## Gate two query process

<b>Strategic solution(s)</b>	Minworth
<b>Query number</b>	MIN006
<b>Date sent to company</b>	12/12/2022
<b>Response due by</b>	14/12/2022

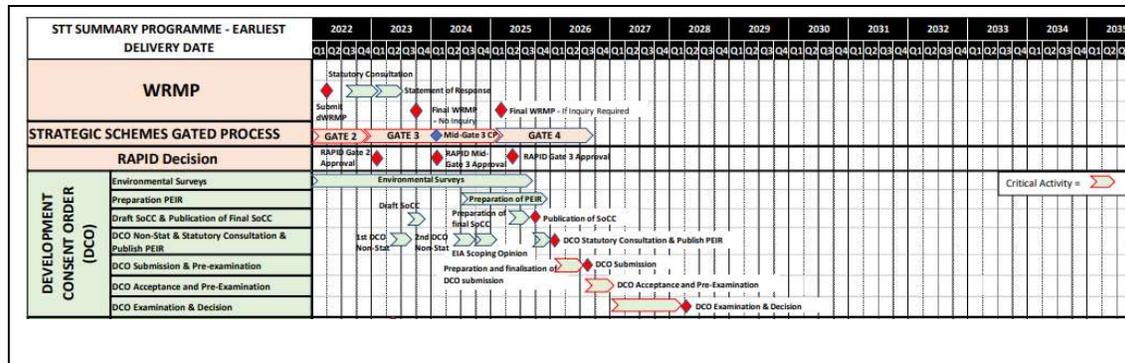
In response to 3 in query MIN003 you state "For Minworth to support STT, the proposed works (tertiary treatment and pipeline) does meet the NSIP criteria given the larger scope of works which is inclusive of a 31km pipeline. Therefore, we have assumed the DCO consenting route is applicable in this scenario and this is reflected in our project plan for this element of the project."

However the project plan (figure 7-1 of the main doc) only shows the DCO route for the element of Minworth that will be consented as part of GUC and does not show the plan for a separate DCO for the STT pipeline. It also does not show the procurement plan for the STT pipeline.

Can you confirm:

- the DCO timeline for the STT pipeline and whether it is expected to be the same as that for the GUC.
  - The procurement timeline for the STT pipeline.
-

We have assumed that the DCO timeline for the STT pipeline element of Minworth SRO will run in parallel to the STT DCO application. This is because:

- This element of the project is only required should the STT SRO proceed
- The timing will be dictated by the STT SRO
- The two separate DCO applications will be linked.

However, the DCO process for this SRO could be offset from STT if the two separate applications can be delivered and the Competitively Appointed Provider (CAP), appointed as part of the DPC process, is comfortable they can be run independently.

The timeline for the STT SRO is shown in Section 7, Figure 7.1 of the Gate 2 submission. However we have include the relevant DCO extract below for completeness:
